TRANS/WP.29/GRE/2004/6
16 January 2004

PROPOSAL FOR DRAFT AMENDMENTS TO REGULATION No. 112

(Headlamps emitting an asymmetrical passing beam)

Transmitted by the expert from the Working Party "Brussels 1952" (GTB)

"D Class C headlamp for right-hand traffic

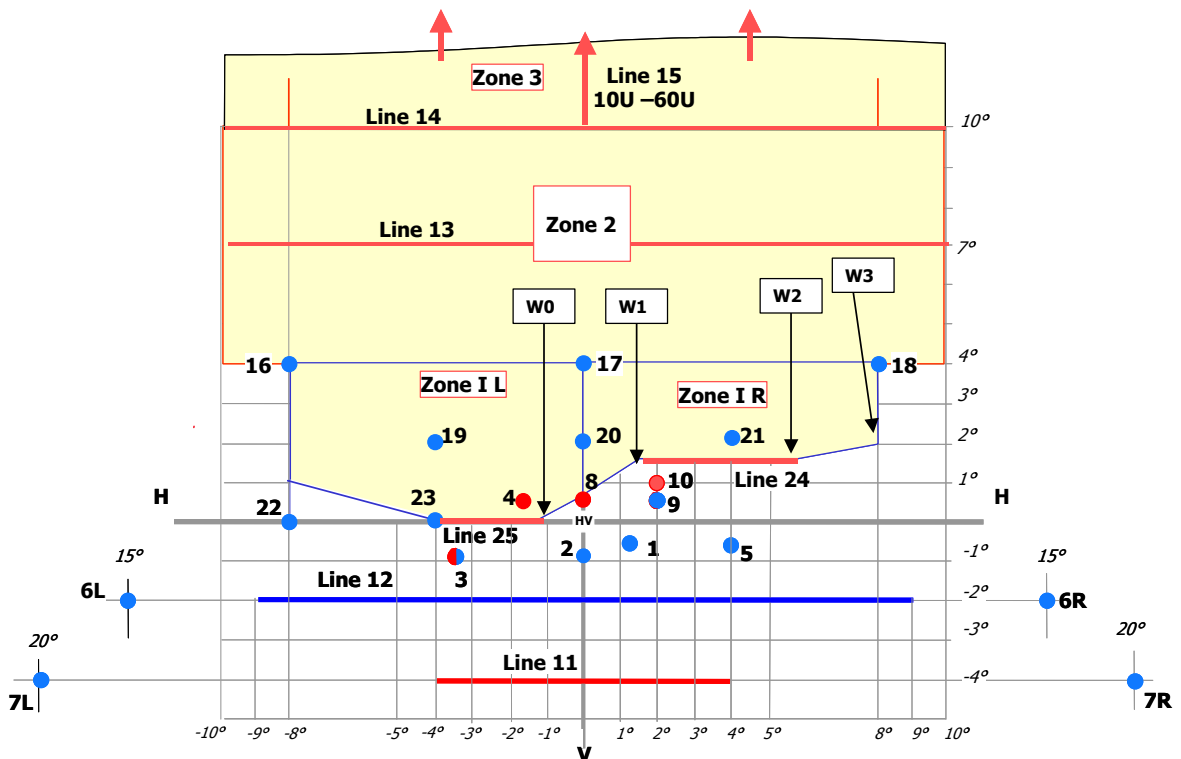
Insert new figures D and E, to read:

6.2.1.2. **For Class C headlamp: On the other side, it must not extend above or to the left of the line connecting the points W₀, W₁, W₂, W₃ positioned as follows (see annex 3): W₀: 1.0 degree Left - H**

W₁: 1.5 degree R-1.5 degree U
W₂: 6.0 degree R-1.5 degree U
W₃: 8.0 degree R-2.0 degree U

Major Changes from first proposal to GRE (TRANS/WP.29/GRE/1999/18)

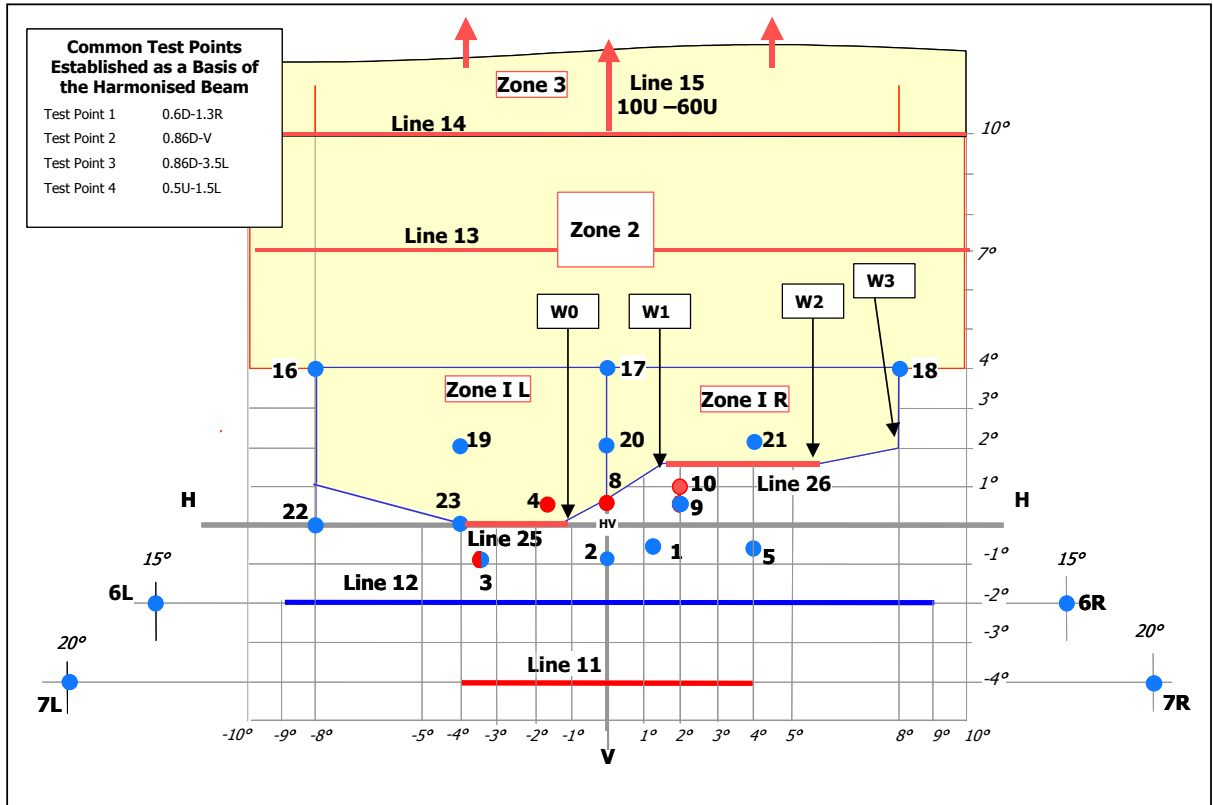
1. In the spirit of harmonization, it has been decided to specify luminous intensity values (cd) and to adopt the angular coordinate system to define test point positions.

2. The positions of the four common test points established as the basis for harmonization of the passing beam have been maintained as contained in TRANS/WP.29/GRE/R.210/Rev1/Add.1 of 25 July 1995.

3. The value at test point 1 has been increased from 7500 cd (12.0Lux) to 10,000 cd (16 Lux) to provide increased illumination along the nearside kerb and to harmonise with USA practice

4. The “Glare Zone” has been split into Zone 1L and Zone 1R. The existing ECE glare values of 440 cd (0.7 Lux) have been maintained in the Zone 1L and the maximum value in Zone 1R has been increased to 625 cd (1.0 lux) to allow improved beam performance along the nearside kerb whilst maintaining acceptable glare control.

5. Control around the HV point has been maintained by the introduction of point 8 and lines 24 and 25.
6. Points 9 and 10 have been added to provide sufficient illumination of road signs and to control glare in rear view mirrors.

7. Zones 1, 2 and 3 are to be scanned only if streaks or spots are clearly visible.
8. The extent of zone 3 has been limited to 60 deg up to allow more efficient headlamp designs to be produced with improvements in the road surface illumination because of the need for reduced shielding of the filament.
